PERMIT

SEWAGE DISPOSAL SYSTEM

MARYLAND STATE DEPARTMENT OF HEALTH
HOWARD COUNTY

PROPERTY OWNER Trinity E. U. B. Church of Rockland

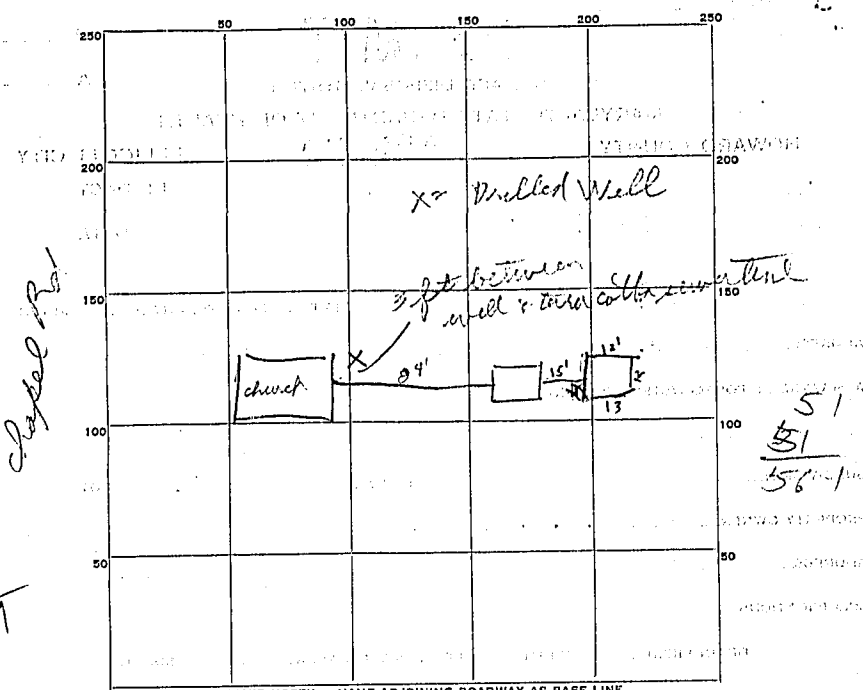
OTHER 450 sq. ft. tile field, dry-well would work here too

SEEPAGE PITS, INSIDE DIAMETER 9 FT. DEPTH BELOW INLET 11 FT.
 ABSORBENT AREA 300 SQ. FT. not counting stone
 REMARKS Perimeter of hole = 14 + 12 + 12 + 13
= 51 ft - sidewalk area counted
above is 561

11/10/60 There is a well within 3ft of the house sewer
made of terra cotta. Any part of the house sewer within 50ft
of the well must be cast in RH

DATE SYSTEM APPROVED 11/14/60 INSPECTOR Raymond Rodger
cast 1 iron pipe installed to tank
